August 1, 2024
File No. 03.0035410.00

Re: Peer Review of Stormwater Mound Evaluation and Design Groundwater Elevation
Proposed Thorndike Place Residential Development
Arlington, Massachusetts

Large Infiltration System V-1

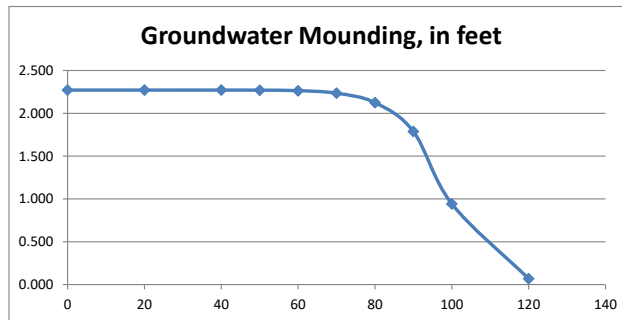
If the stormwater infiltration system was instantaneously filled with the required recharge volume of 1,638 cubic feet and then discharged out of the system at the K_v design rate of 0.27-inches per hour (0.54 feet per day), it would take 8.96 hours to drain (i.e., 0.374 days). GZA's initial groundwater mound analysis using the Hantush method and the values listed above (Large Infiltration System V-1) is provided in Appendix B and indicates that maximum groundwater mound would be 2.27 feet.

Large Infiltration System V-2

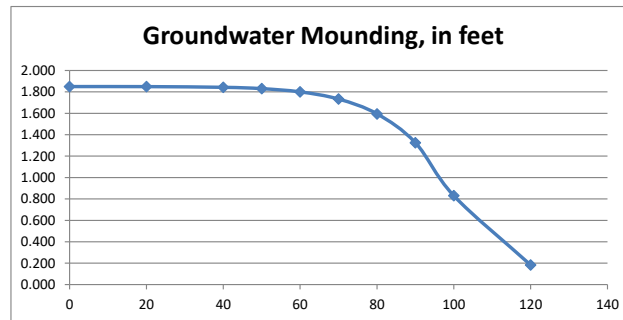
However, it is more likely that the required recharge volume would flow out of the infiltration basin over the duration of one day. GZA's second groundwater mound analysis (Large Infiltration System V-2) assumed the same conditions as the Large Infiltration System V-1 except the duration was one day and the applied recharge was 0.2014 feet per day. The resulting maximum groundwater mound would be 1.85 feet (see Appendix B).
